HOLLY TOWNSHIP
PROPOSED AGENDA
PLANNING COMMISSION
September 10, 2025 at 6:30 PM
Holly Township Hall (Upstairs)
102 Civic Dr., Holly, Michigan 48442

TO: Holly Township Planning Commission
FROM: Alexis Farrell, AICP, NCI, Senior Planner
SUBJECT: Krane Heating and Cooling - Special Land Use Review #2
DATE: September 3, 2025

TO: Holly Township Planning Commission
FROM: Alexis Farrell, Senior Planner
Elizabeth Hart, Senior Planner
SUBJECT: Krane Heating and Cooling - Site Plan Review #2
DATE: September 3, 2025

Re: 3008 Grange Hall Road – Krane Heating & Cooling Storage Addition
Site Plan – Worksheet Sidewalk Plan Review

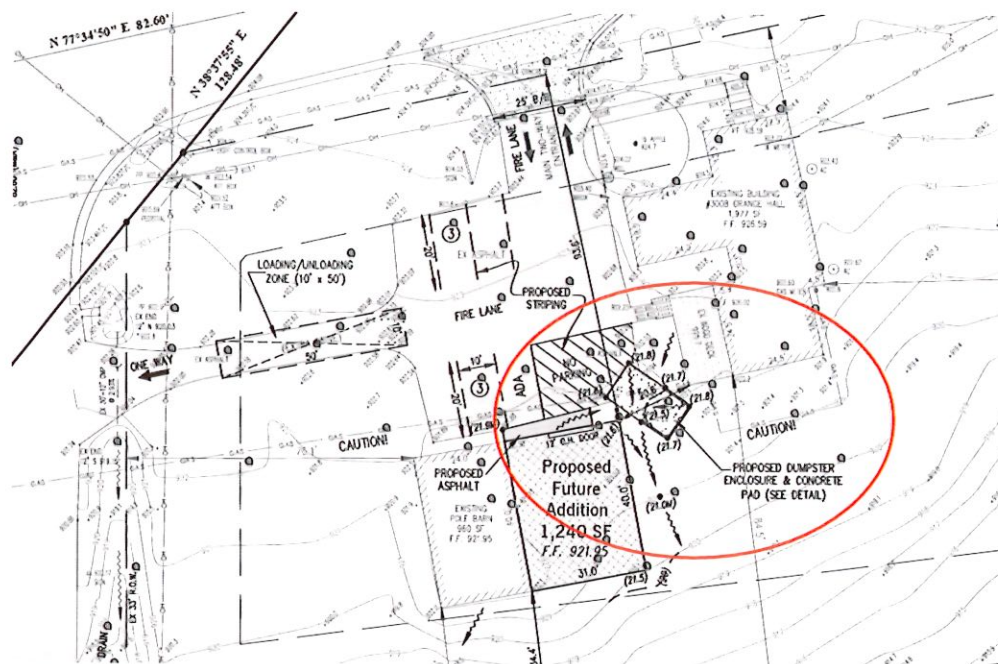
Outdoor Trash Storage Area Screening (Section 32-192 (i)). Currently, there is no screening or enclosure on the site. The dumpster has been kept unscreened between the existing pole barn and office building. A trash enclosure is proposed on the originally submitted plans (dated April 28, 2025), relocating the dumpster and constructing an enclosure in front of both the pole barn and office building on the western side of the site, considered the front yard. This does not comply with Section 32-192 (i)(3), which states "Containers and enclosures shall be located away from public view insofar as possible." As such, the applicant submitted revised plans dated July 16, 2025, which show the enclosure proposed between the pole barn and the principal structure, which is much less prominent on the site and complies with this standard.

A minimum 6-foot fence and gate are proposed for the enclosure, with a note that it will be comprised of either metal or wood. As noted previously, the screening standards require screening materials to be compatible with the architectural materials used in site development, so this must be clarified on the final plan set, which can be approved administratively.

1. **Pedestrian Connectivity:** The materials and additional construction details for the proposed pathways must be added to the plans and approved administratively.
2. **Trash Enclosure:** The dumpster enclosure material should be specified on the final plans, and the proposed relocation between the office and pole barn addition approved by the Fire Chief administratively before final approval is granted.
3. **Lighting:** The photometric plan should be updated to reflect the newly proposed sconces to ensure compliance, which can be reviewed administratively before final approval.
